M12 Motorway

Amendment Report

October 2020

Figure 2-1 Key features of the amended project

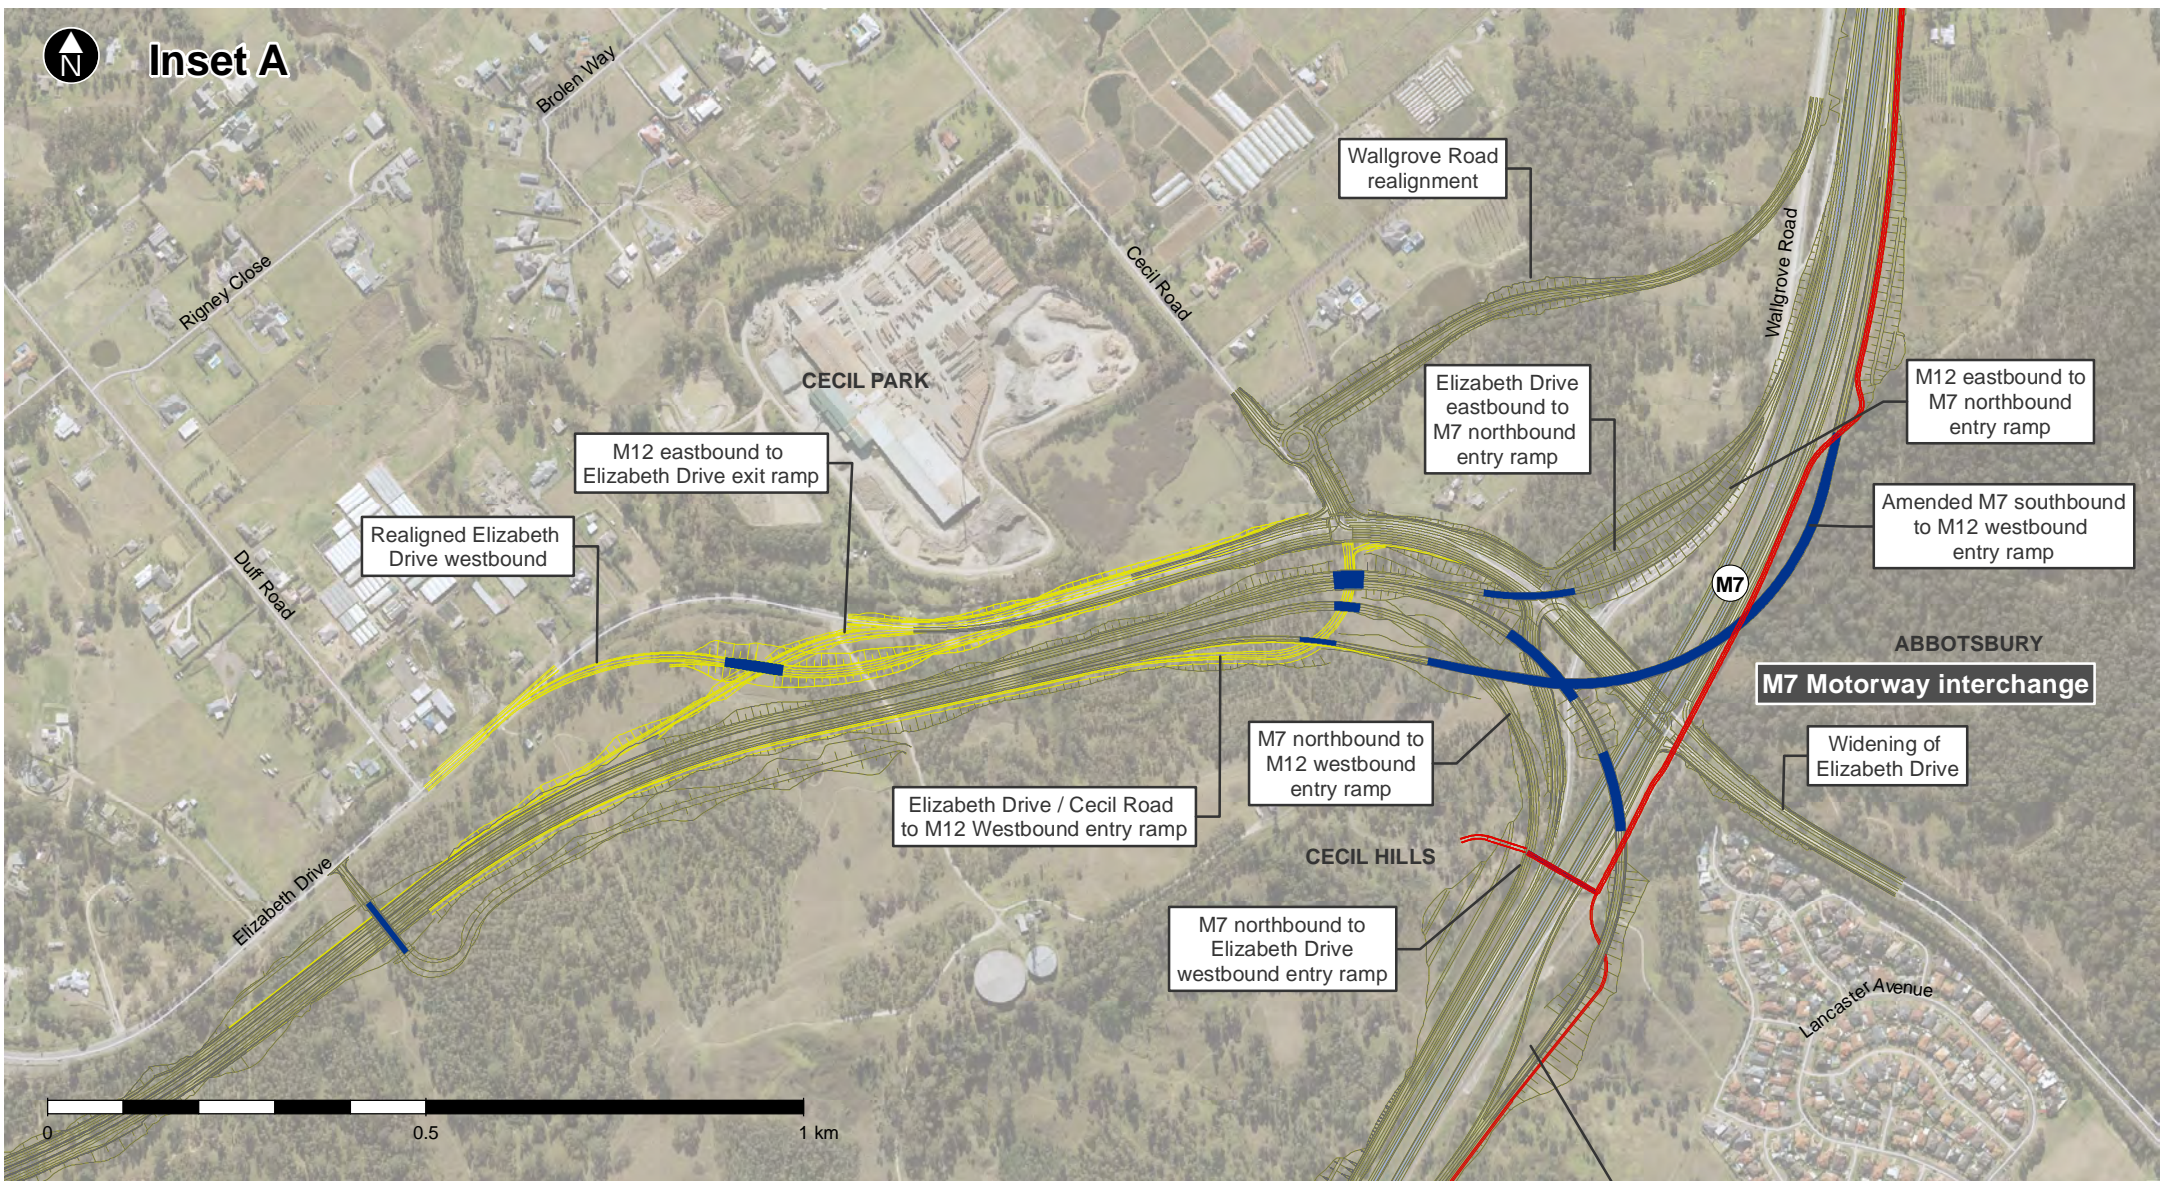
This section of the amended project is shown in **Figure 2-1**, with the Elizabeth Drive connection associated with option 2 shown in a different colour and detailed in inset A.

An overview of the key features of the amended project is provided in **Figure 2-1**. Additional figures presented throughout Chapter 3 show the changes from the project as described in the EIS.

Figure 3-2 Proposed amended project bridges

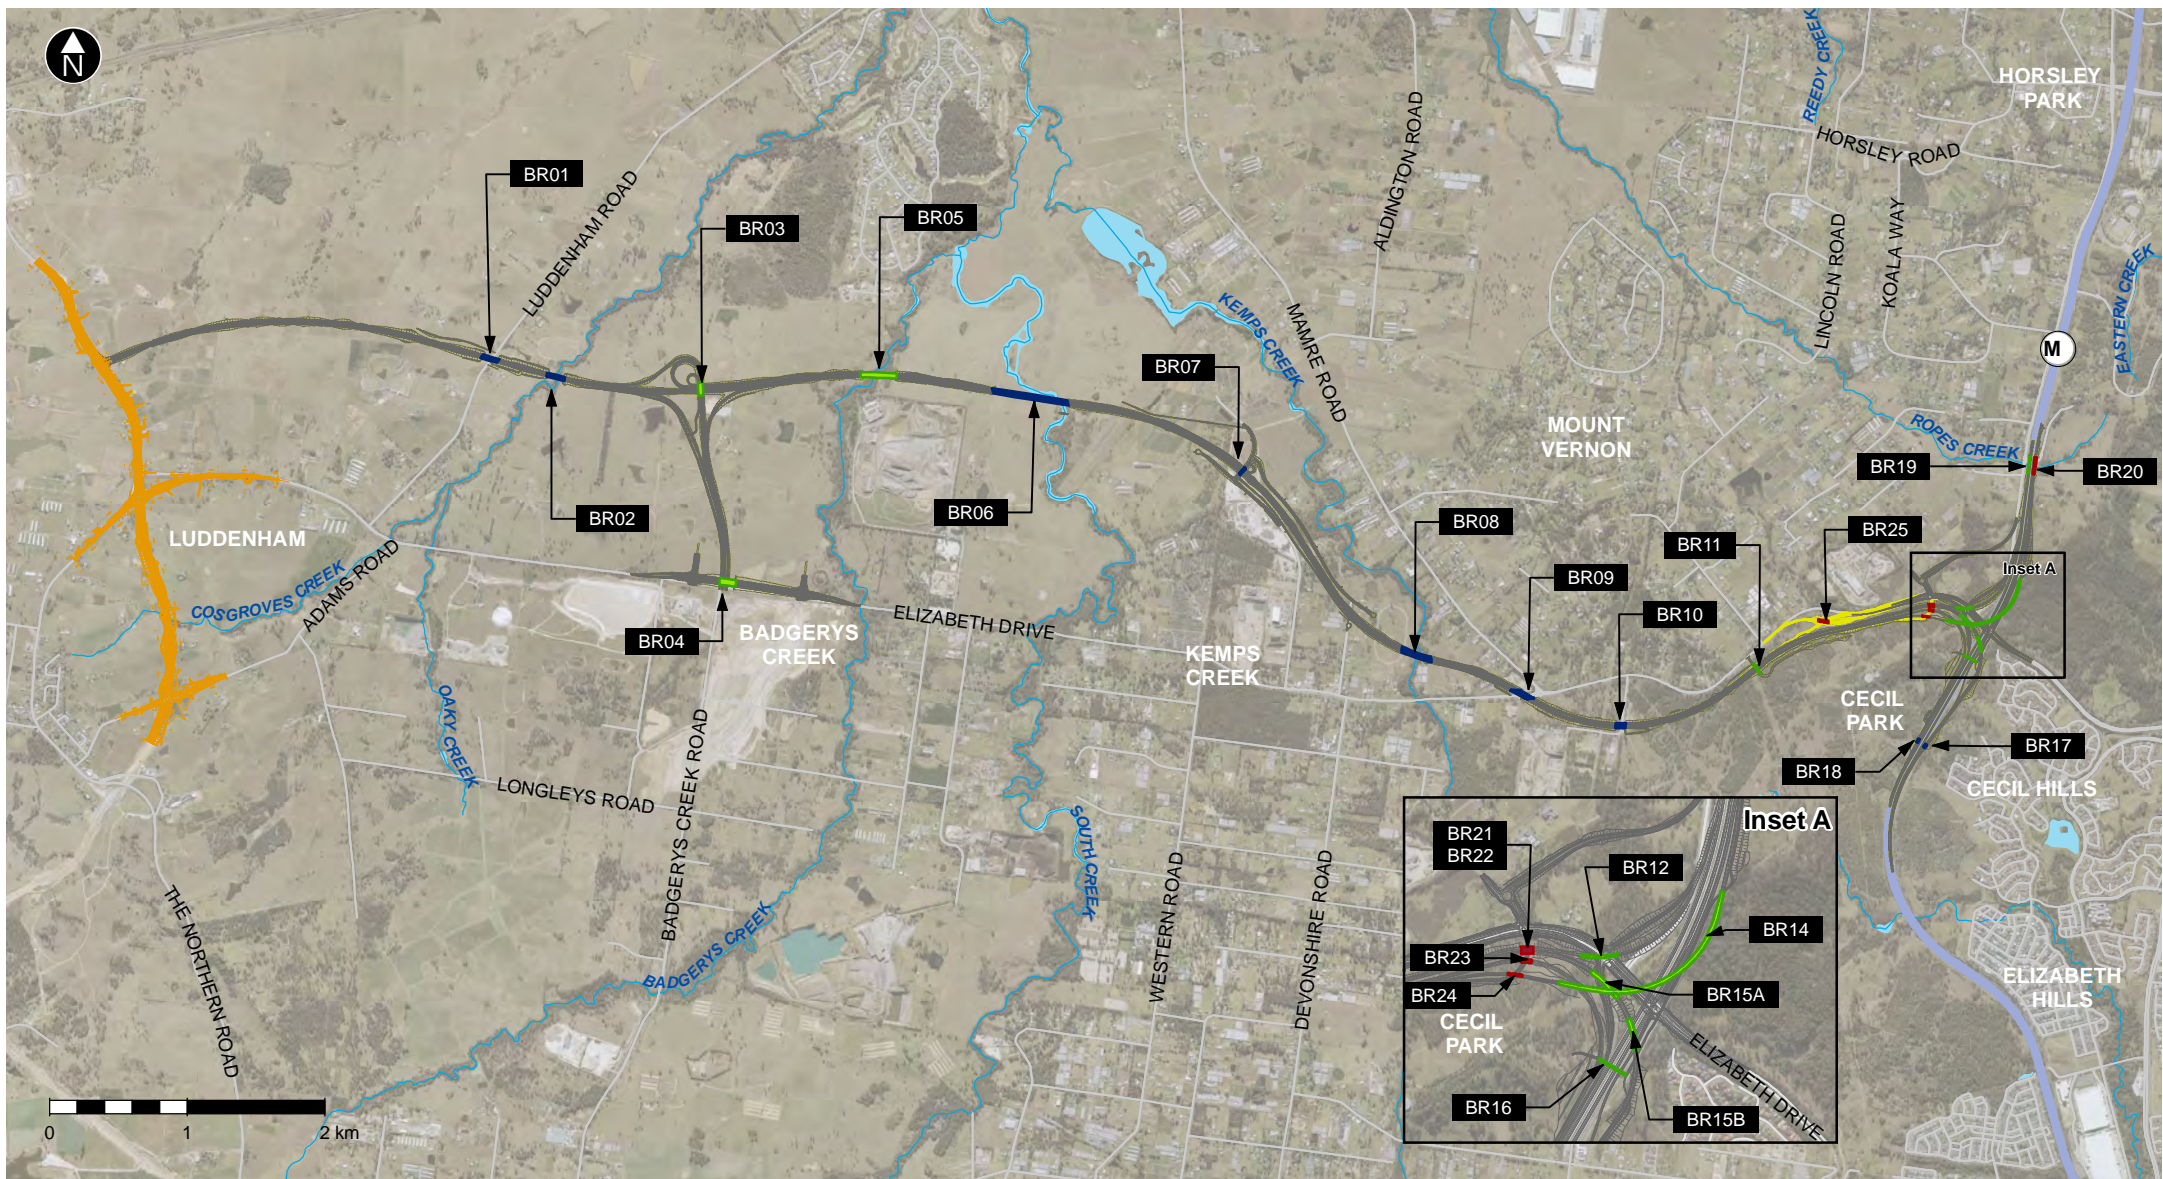
The described amendments to the motorway-to-motorway interchange at the M7 Motorway would result in changes to bridges as they were described in Section 5.12 of the EIS. Bridge 13 would no longer be required, and five additional bridges are proposed, primarily to facilitate a connection between the M12 Motorway and Elizabeth Drive, bringing the total number of bridges constructed to 23. The additional bridges would be constructed in the form of a multi-span precast concrete super-T girder, an example of which is shown in Figure 5-10 of the EIS. Details of the new bridges are listed in **Table 3-1** and shown in **Figure 3-2**.

Bridge 24 M7 Motorway southbound exit ramp to M12 Motorway westbound bridge over M12 Motorway westbound entry ramp from Elizabeth Drive Configuration would be two lanes and shoulder	Multi-span precast concrete super- T girder	L = about 36 m W = about 10 m
